1959 Corvette: Service Bulletin: Excessive Driveline Vibration

Subject: Excessive Drive Line Vibration

Model and Year: 1959 Corvette

Date: September 30, 1959

The propeller shaft and pinion angle and the elongation of the radius rod mounting bracket hole is shown in Fig. 44.

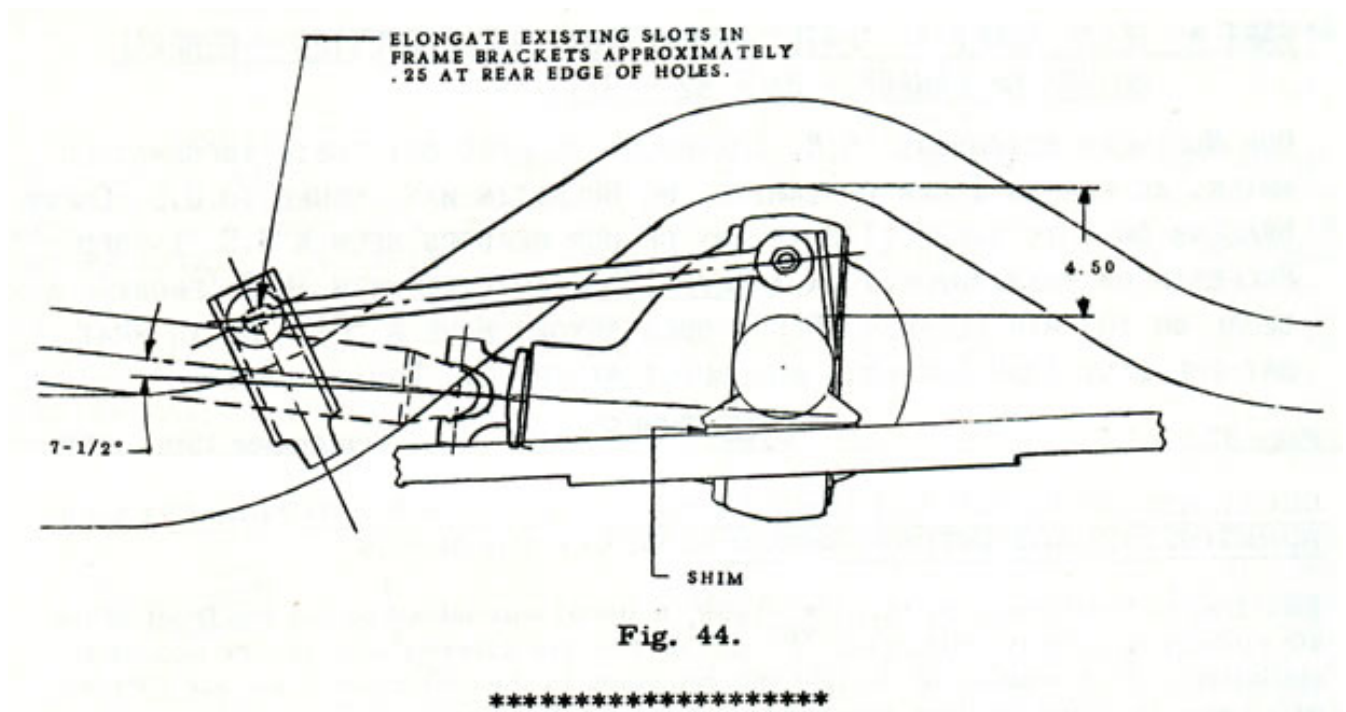
If excessive drive line vibration is encountered on the 1959 Corvette, it is probably due to excessive rear U-joint angle. Elimination of the vibration can be accomplished by installing either a 2° or 3° shim between the axle pads and springs on both sides, with the thick side to the front.

The nominal angle of the rear U-joint is 7-1/2°. Care should be taken in not going under 7-1/2° due to interference at full bump position.

1. Load vehicle until distance between the axle housing and the frame rail kick (metal to metal) is 4-1/2". Retaining the vehicle in this position, the angle of the propeller shaft and pinion nose can be measured, as shown in the 1958 Passenger Car Shop manual.

2. The radius control rods should be disconnected before installing the shim. Before re-attaching the radius control rods, elongate the radius rod frame mounting hole 1/4" rearward if necessary to eliminate any interference between the radius control rods attaching bolt and mounting bracket. Shim part #3722797 (2 °), or #3744488 (3 °), or their equivalent may be utilized. The locating tab on the above shims should be removed to allow the shim to lie flat.
